Access Compliance Report Public Rights-of-Way (Curb Ramps)

Main Street: RED_HILL_AVE Cross Street: N/A Location: N

ADA ID: RPRK220107120512 Ramp Type: Type 1 - Perpendicular Diagonal Initial Pass/Fail: Pass Overall Compliance: No Severity Score: 12

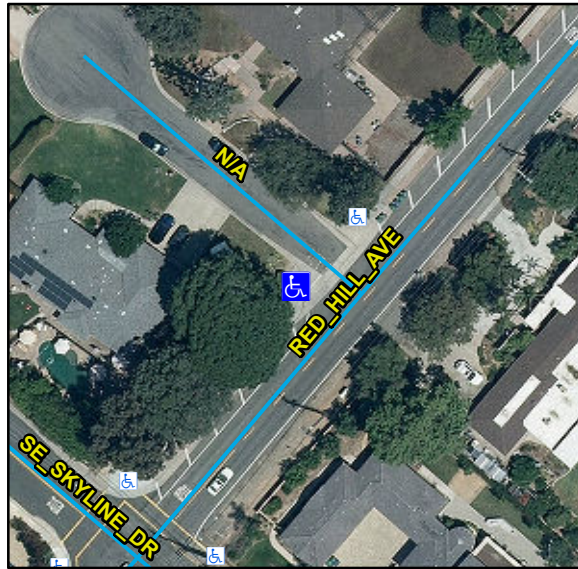
Compliance	Description	Data	Compliance	Description	Data
N/A	Ramp Length (in)	84	N/A	Flare Type LT	
Yes	Ramp Width (in)	48			Sloped
Yes	Ramp Run Slope (%)	7.9	Yes	Flare Slope LT (%)	6.2
Yes	Ramp Cross Slope (%)	1.6	N/A	Flare Traversable LT	Yes
N/A	Landing Present	Yes	N/A	Flare Type RT	
N/A	Landing Length (in)	34			Sloped
Yes	Landing Width (in)	48	N/A	Flare Slope RT (%)	5.8
No	Landing Run Slope (%)	3.1	N/A	Flare Traversable RT	No
Yes	Landing Cross Slope (%)	1.7	Yes	DWS Provided	Yes
N/A	Landing Movement Obstructed?	No	Yes	DWS Contrast	Yes
	Landing Movement Type	N/A	Yes	DWS Length (in)	36
N/A	Landing Shared	No	Yes	DWS Full Width	Yes
N/A	Clear Space	Yes	Yes	DWS Offset Left (in)	0
N/A	Clear Space To Crosswalk (in)	48	Yes	DWS Offset Right (in)	N/A
N/A	Marked Crosswalk 1	No	N/A	Marked Crosswalk 2	No
	Crossing 1 Direction	SE		Crossing 2 Direction	NE
	Marked Crosswalk 1 Width (in)	N/A		Marked Crosswalk 2 Width (in)	N/A

N/A	Ramp Inside Crosswalk 1	N/A	Yes	Ramp Inside Crosswalk 2	N/A
	Crossing 1 Slope (%)	8.3		Crossing 2 Slope (%)	6.5
	Crossing 1 Cross Slope (%)	1.2		Crossing 2 Cross Slope (%)	0.9
Yes	Gutter Ponding	No	Yes	Curb Slope	1.3
Yes	Gutter Lip Height (in)	0		Road Run Slope (%)	1.7
No	Gutter Run Slope (%)	7.8		Road Cross Slope (%)	7
Yes	Gutter Cross Slope (%)	1.4			
Yes	Overall Surface Condition: Acceptable		Yes	Perp Joint Present	Yes
	Cross Gutter Present?	Yes		Spandrel Present?	Yes
	Replace Cross Gutter?	No		Replace Spandrel?	No

Remove & Replace Landing. Remove & Replace Gutter.

R304.2.1, R304.2.2-Perp, R304.3.2-Para, R304.5.4, STD 1115
